Environmental Minor Project Refinement Form

Project Name: West of Devers Upgrade Project **Request Prepared By:** Sylvia Granados

Date Approval Required: 12/6/2019 **Variance Request No.:** 32

FIGURE 1
Page 1 of 13

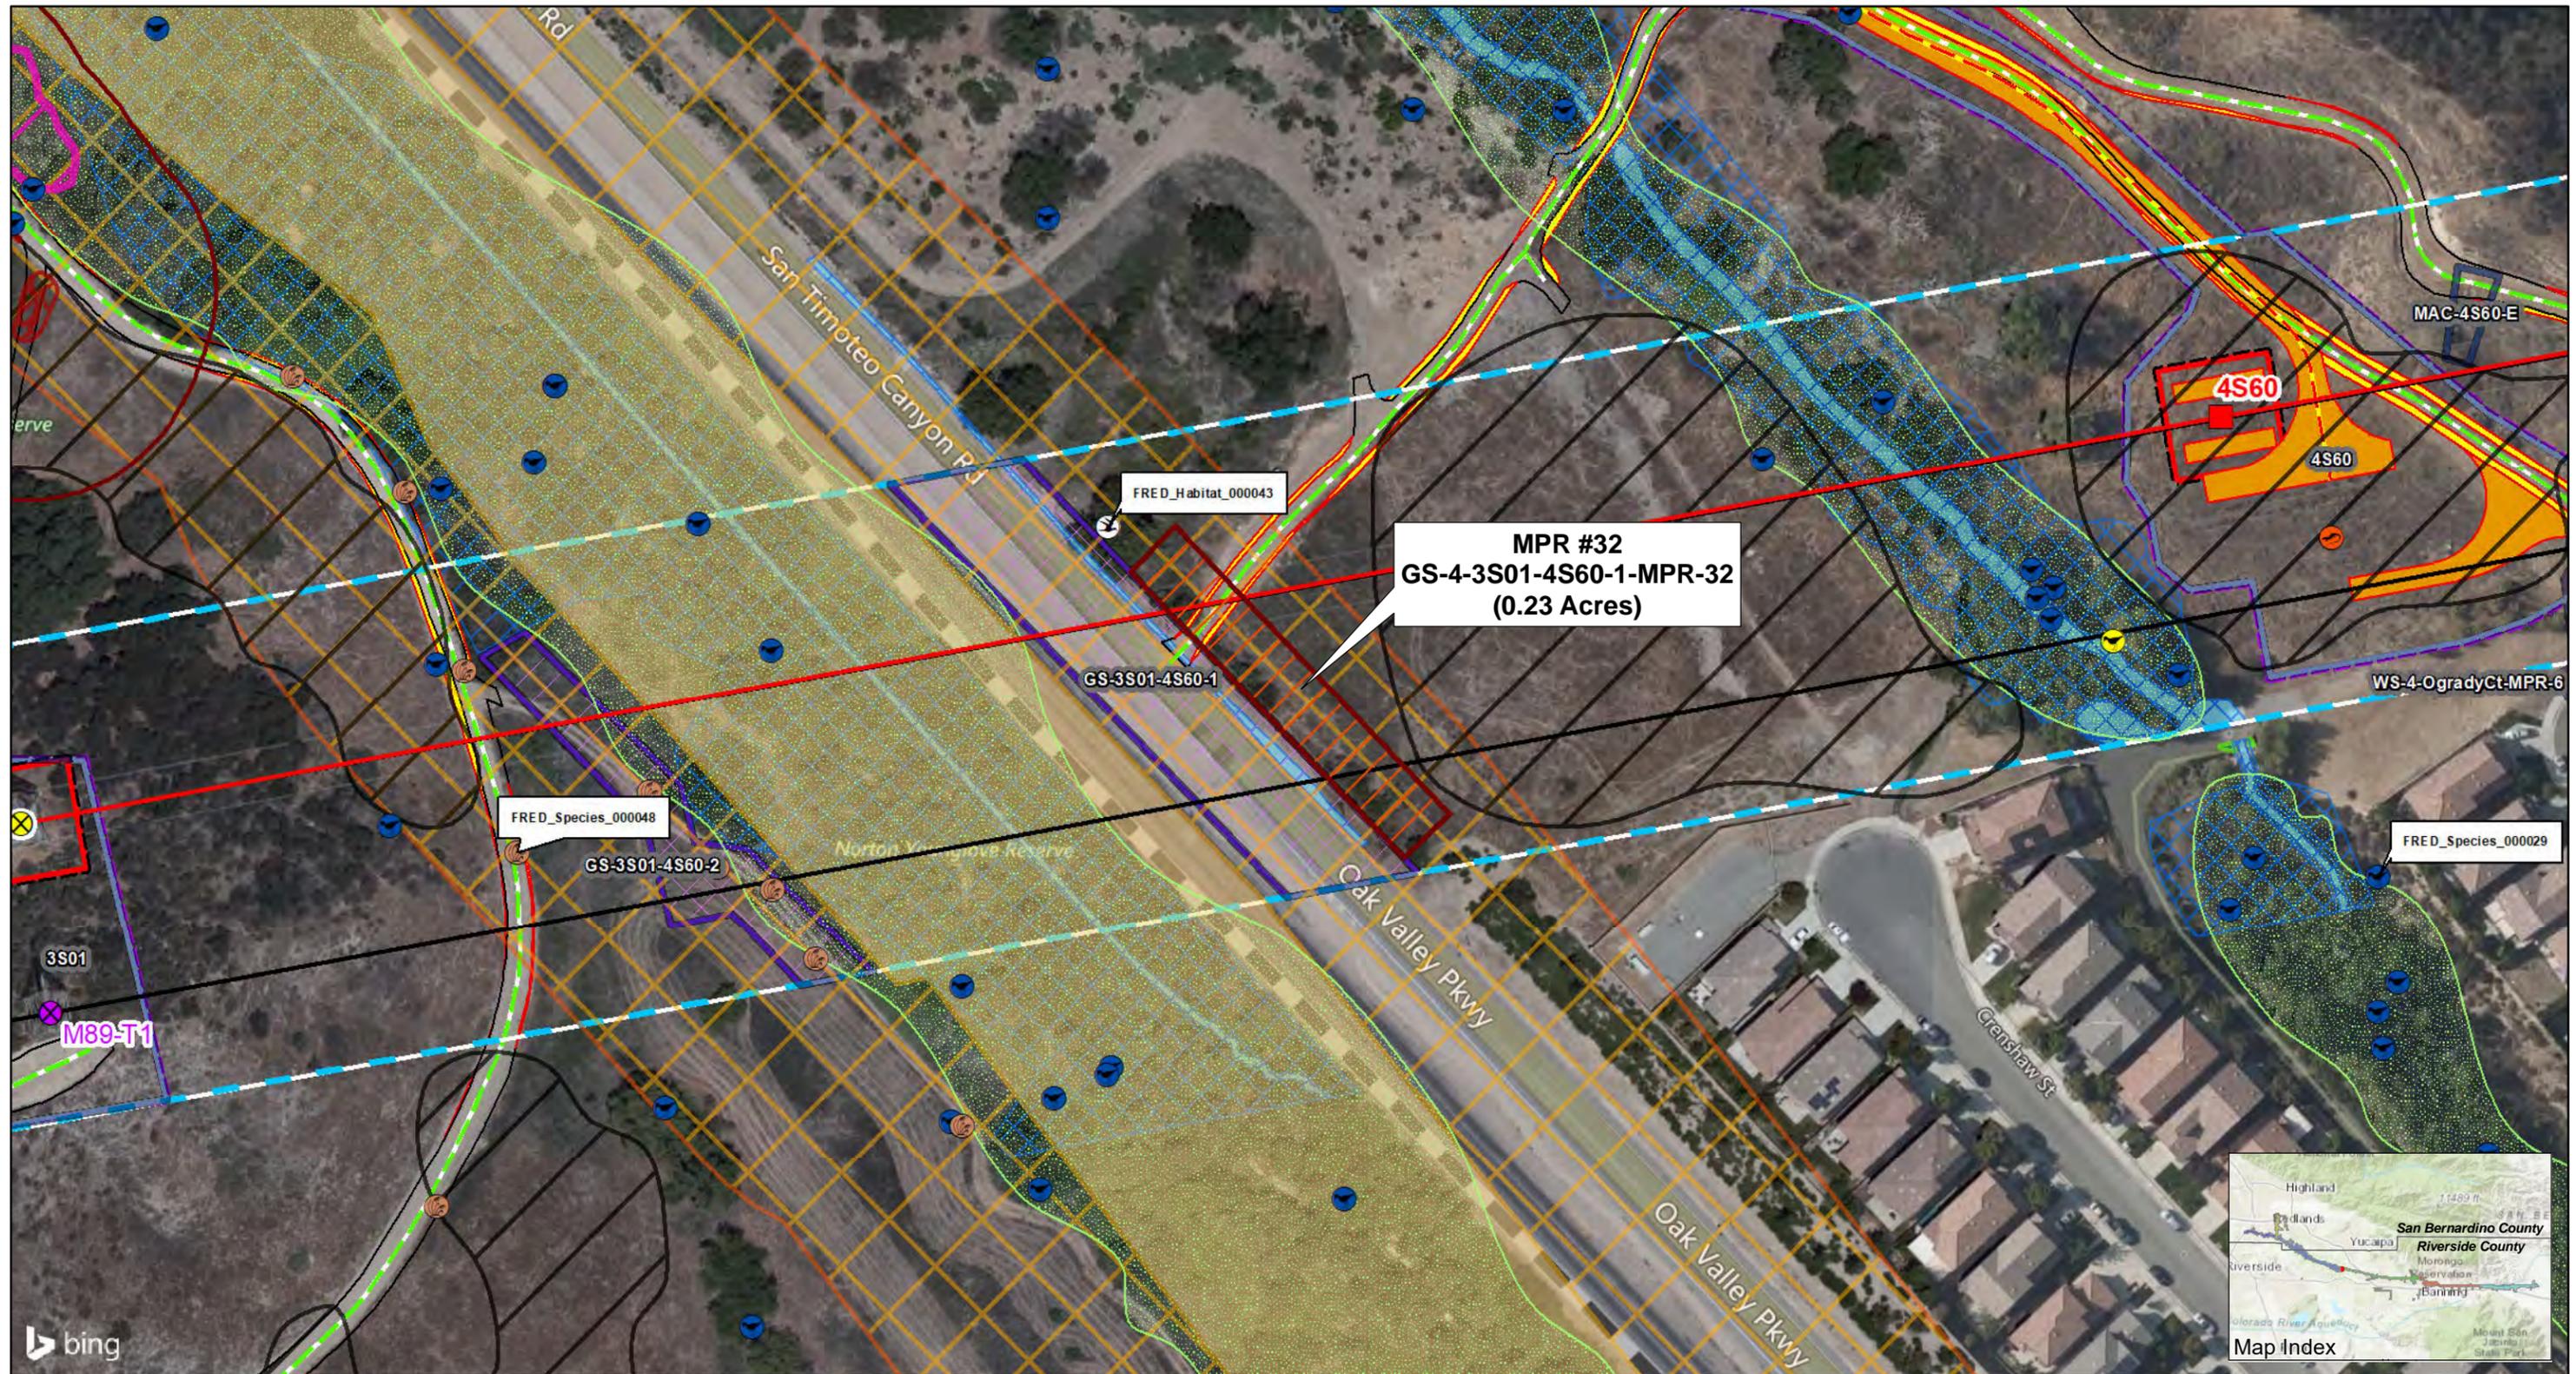
GS-4-3S01-4S60-1-MPR-32: Expansion of GS-3S01-4S60-1 East of San Timoteo Canyon Road and West of 4S60

A new temporary work area adjacent to the east side of San Timoteo Canyon Road and east of GS-3S01-4S60-1 is required to provide adequate work space for material and equipment staging during tower construction, wire stringing activities, and wire wreck-out, as shown on Figure 1, Page 1.

The new work area consists of approximately 0.23-acre of developed/disturbed land (0.04 acre) and grassland forbland (.19 acre). The land is privately owned and located within the SCE transmission line right-of-way.

FIGURE 1
 Page 2 of 13

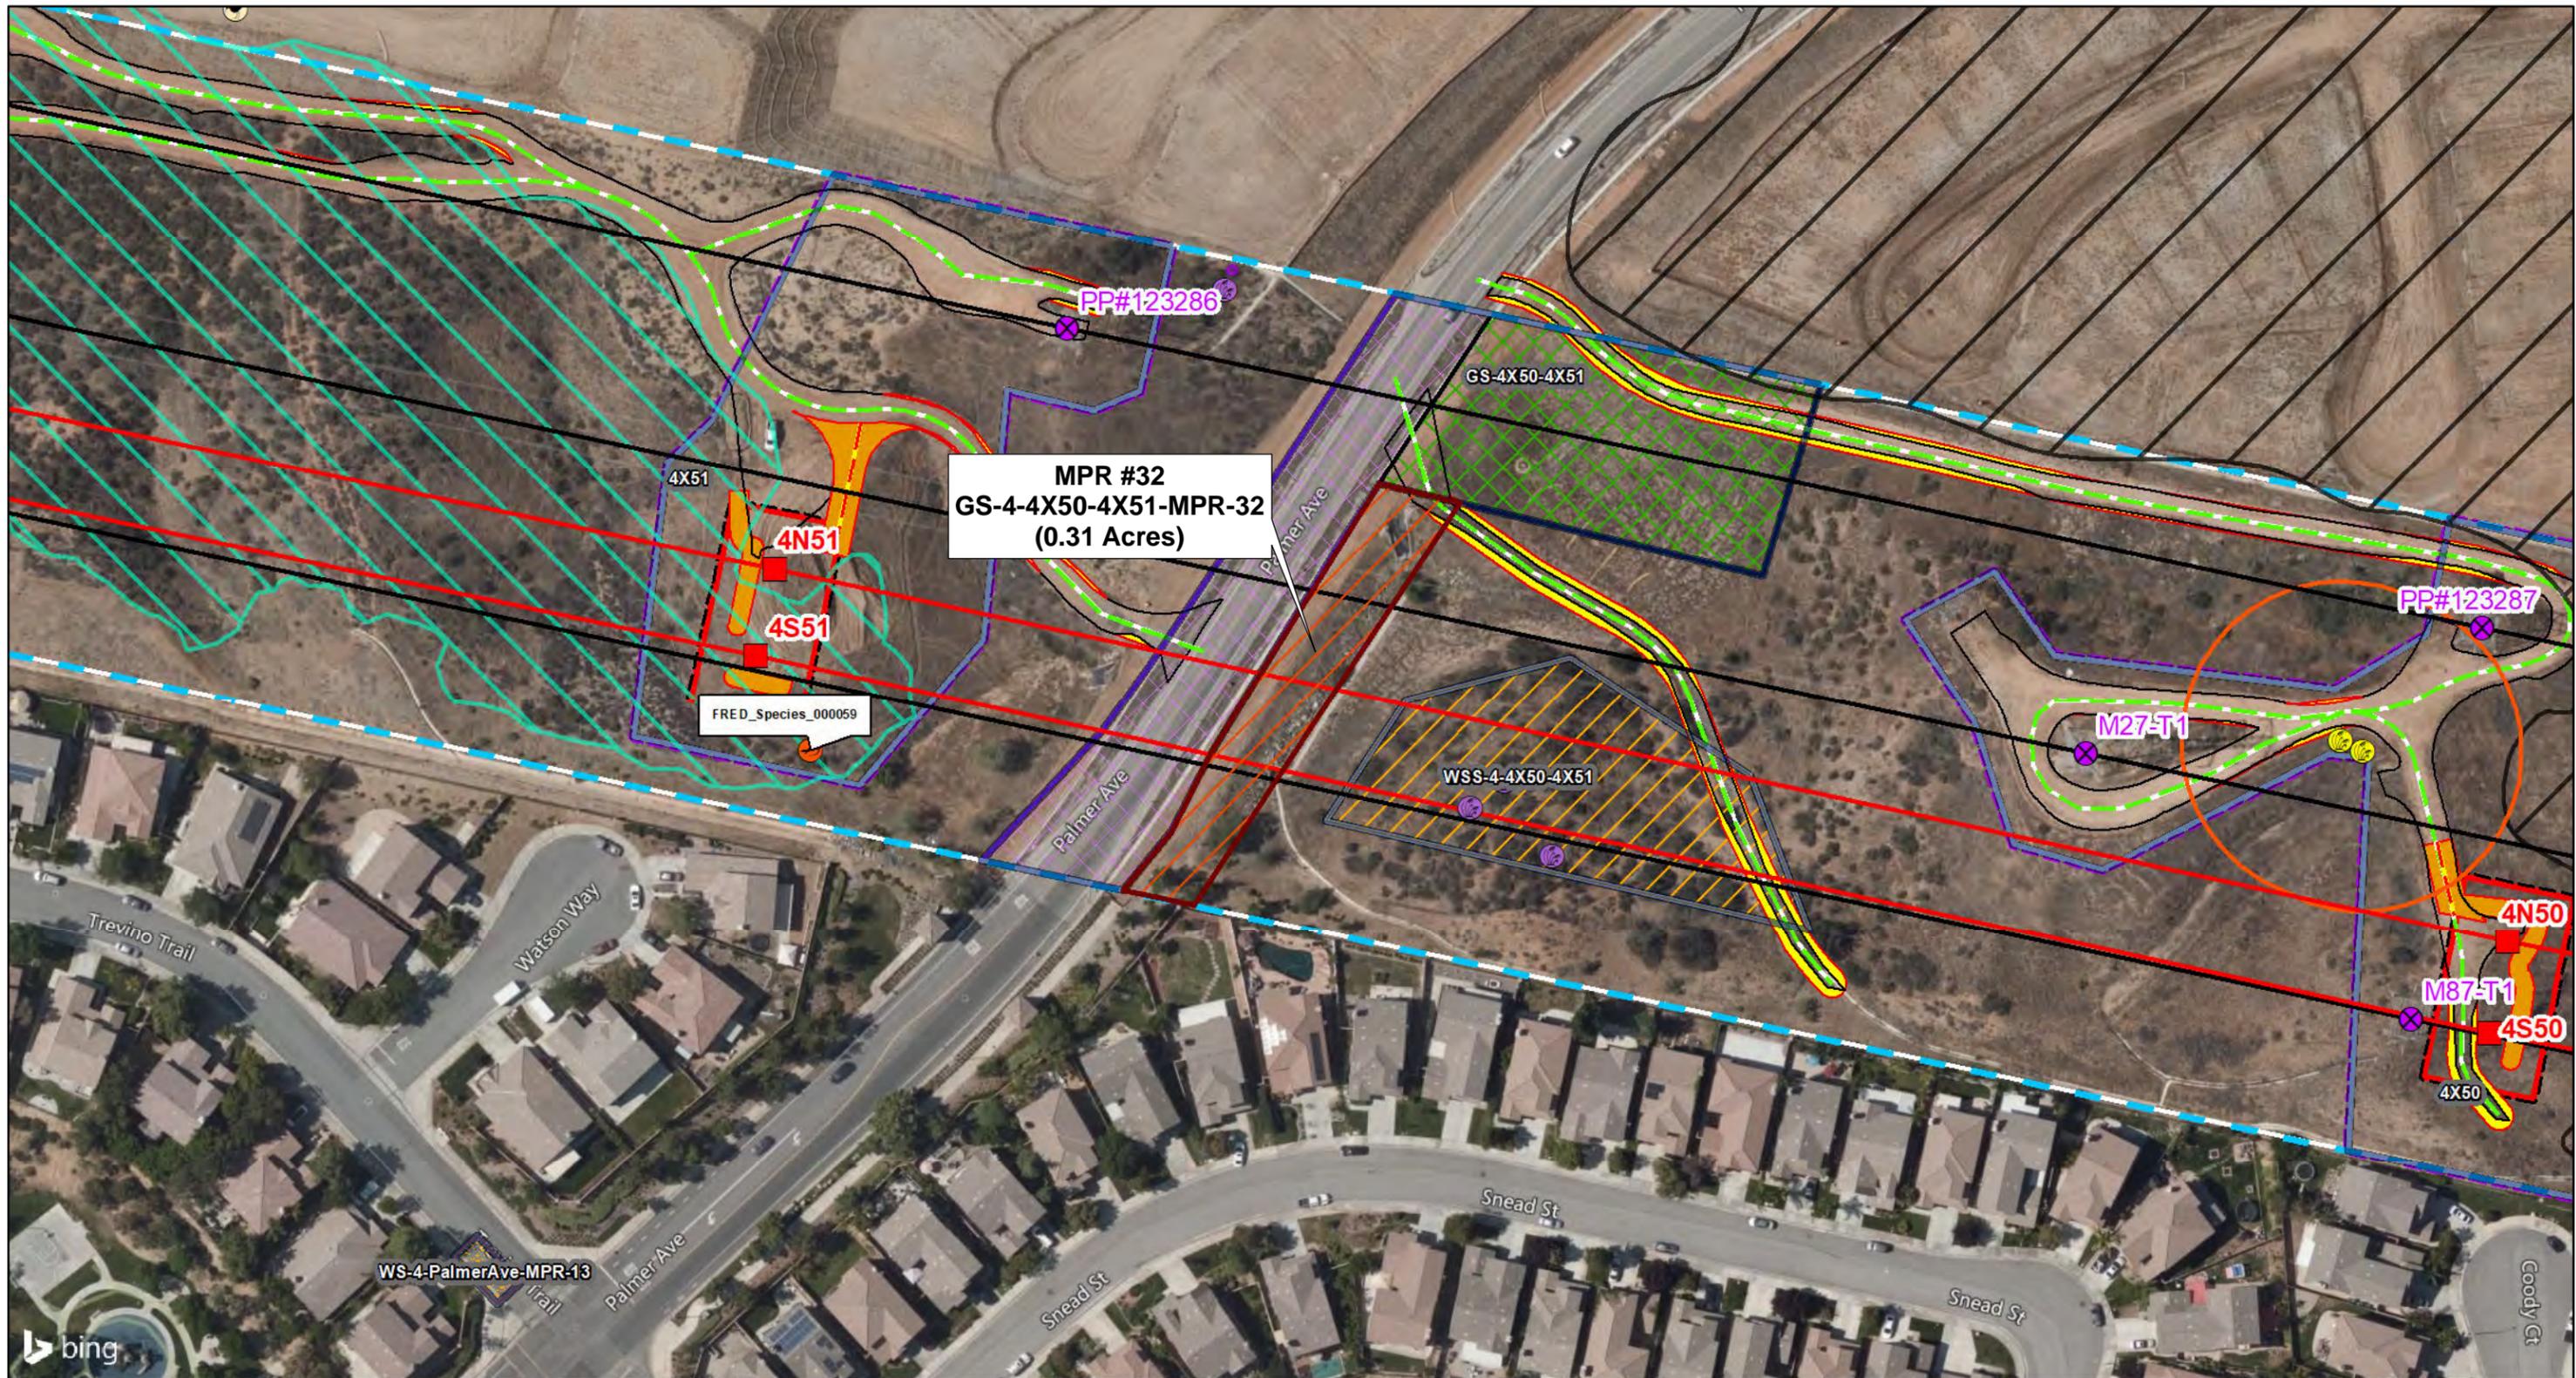
GS-4-4X50-4X51-MPR-32: Expansion of GS-4X50-4X51 East of Palmer Avenue and West of M27-T1

A new temporary work area adjacent to the east side of Palmer Avenue, east of GS-4X50-4X51, and west of Supersite M27-T1 is required to provide adequate work space for material and equipment staging during tower construction, wire stringing, and wire wreck-out activities, as shown on Figure 1, Page 2.

The new work area consists of approximately 0.31-acres of developed/disturbed land (.29 acre) and chaparral (.02 acre). The land is privately owned and located within the SCE transmission line right-of-way.

FIGURE 1
Page 4 of 13

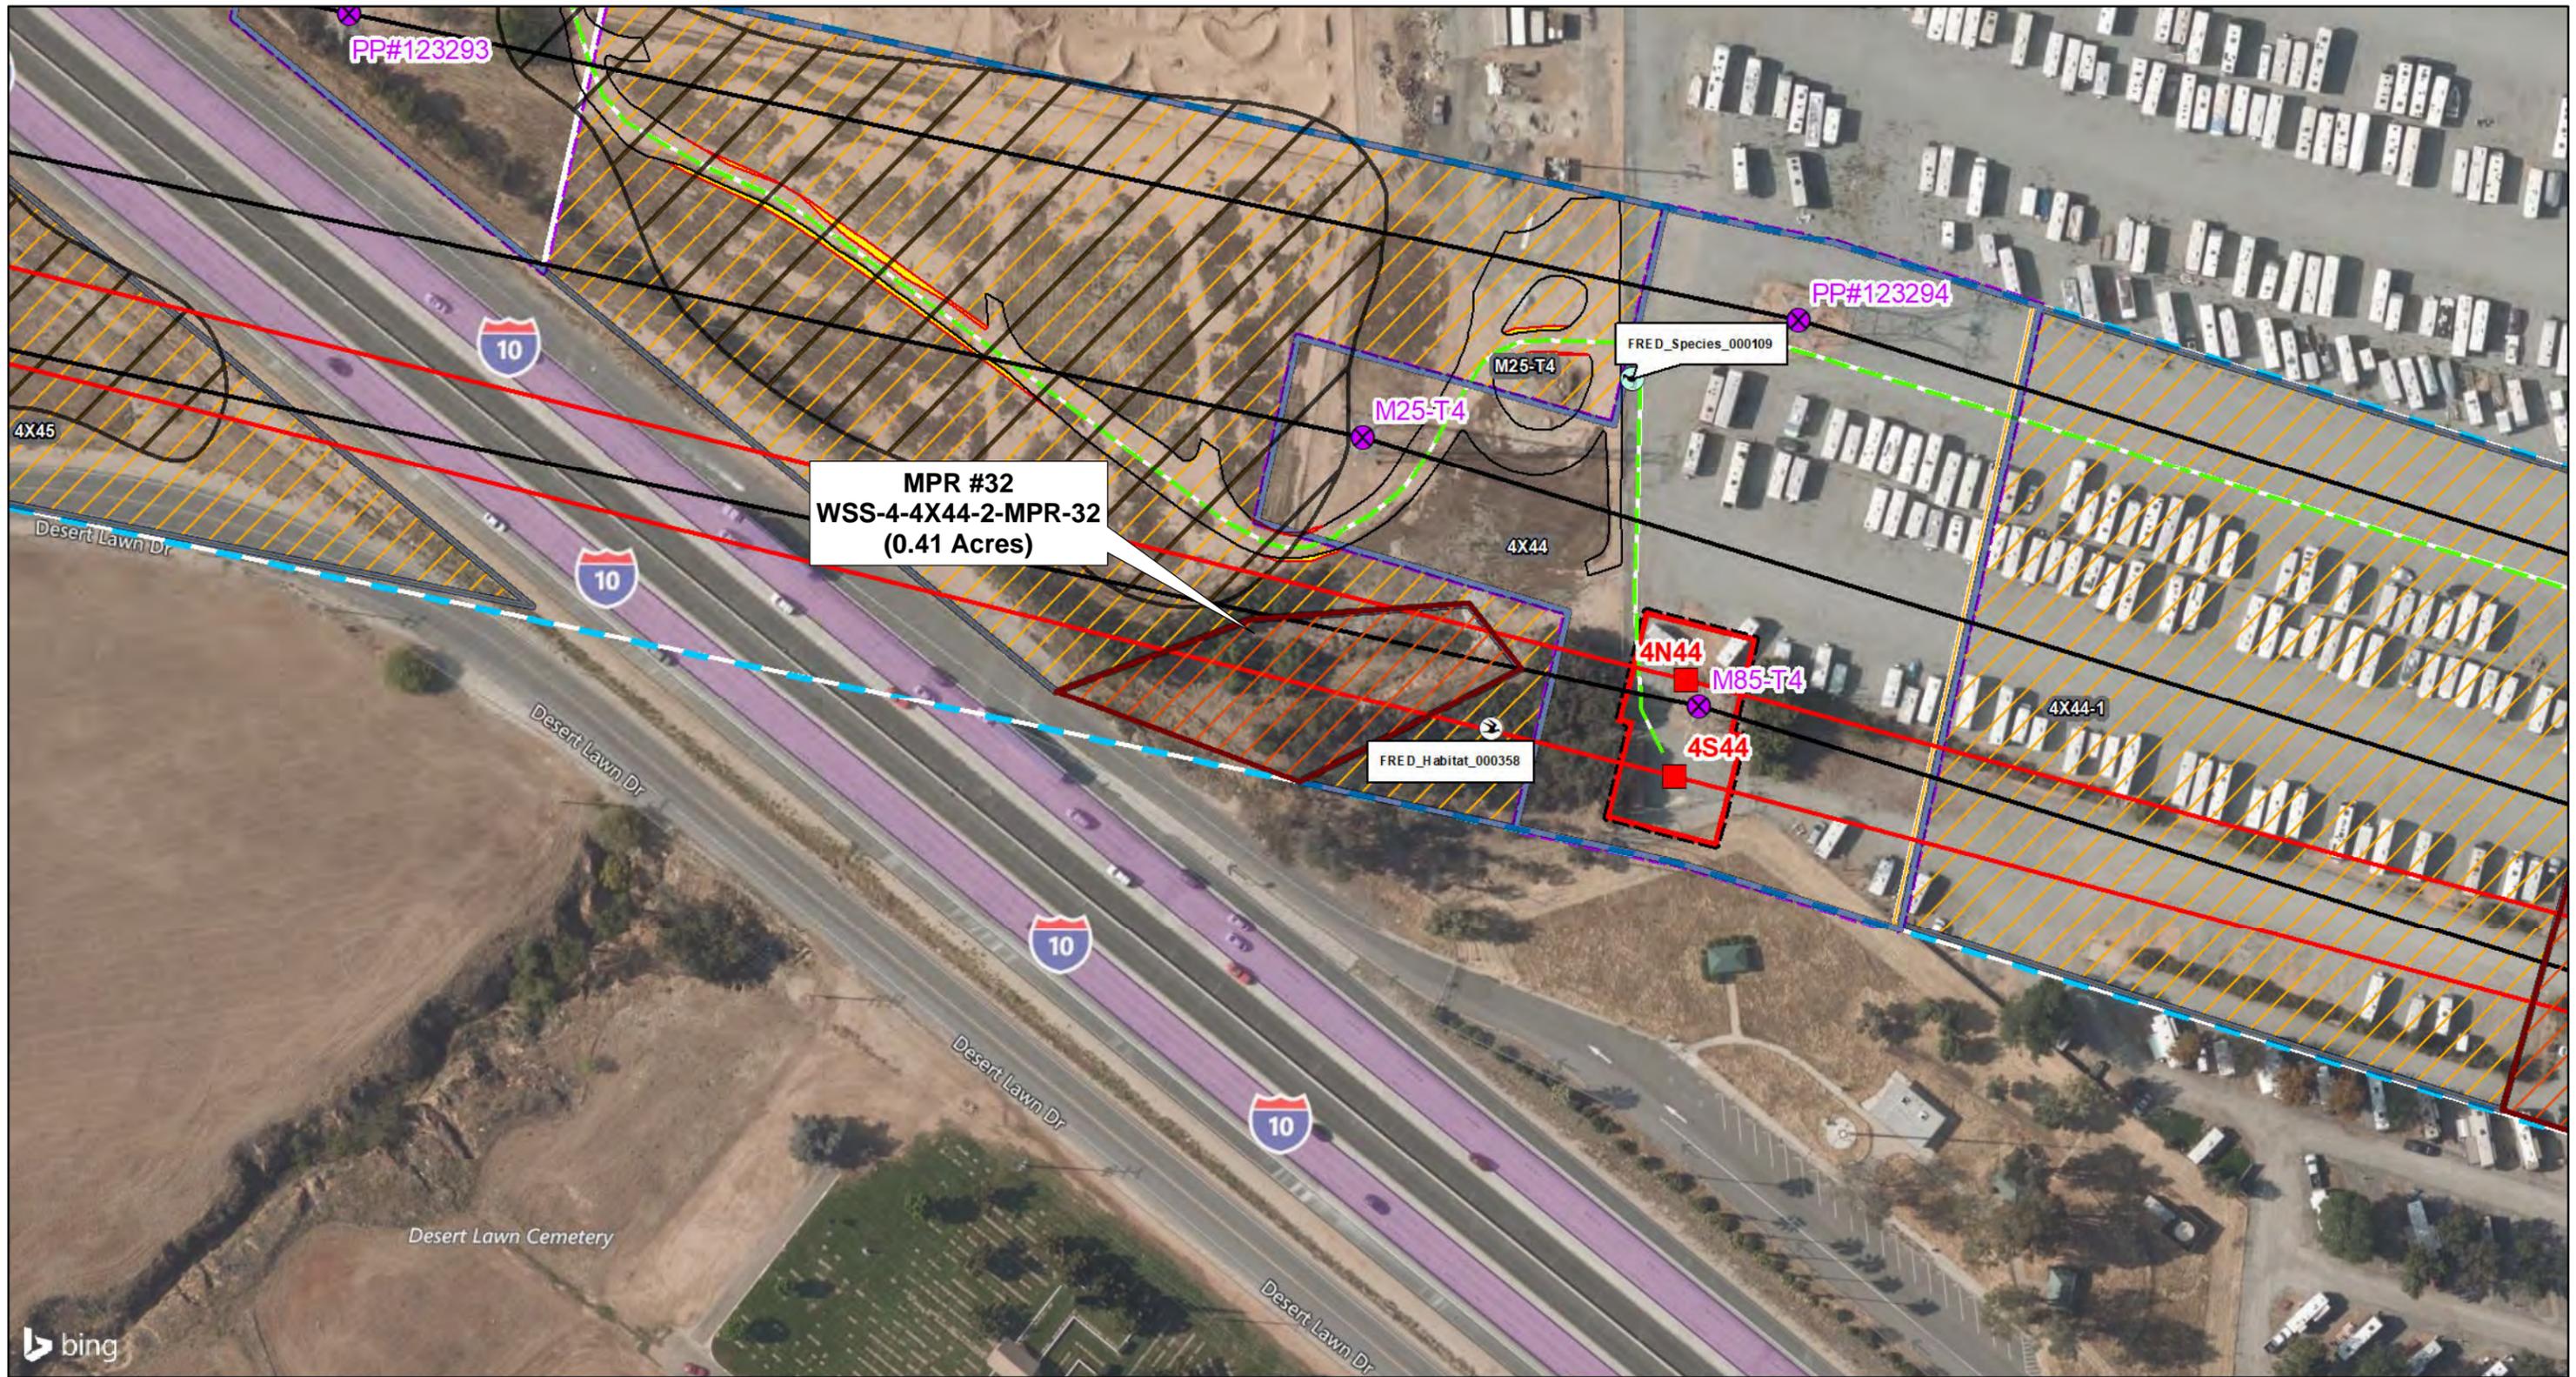
GS-4-4X46-4X47-1-MPR-32: Expansion of GS-4X46-4X47-1 West of Plantation Drive

A new temporary work area along the west side of Plantation Drive within the SCE transmission right-of-way is required to provide adequate work space for material and equipment staging during tower construction, wire stringing, and wire wreck-out activities, as shown on Figure 1, Page 4.

The new work area consists of approximately 0.17-acre of developed/disturbed land (.06 acre) and agricultural (.11 acre). The land is privately owned and located within the SCE transmission line right-of-way.
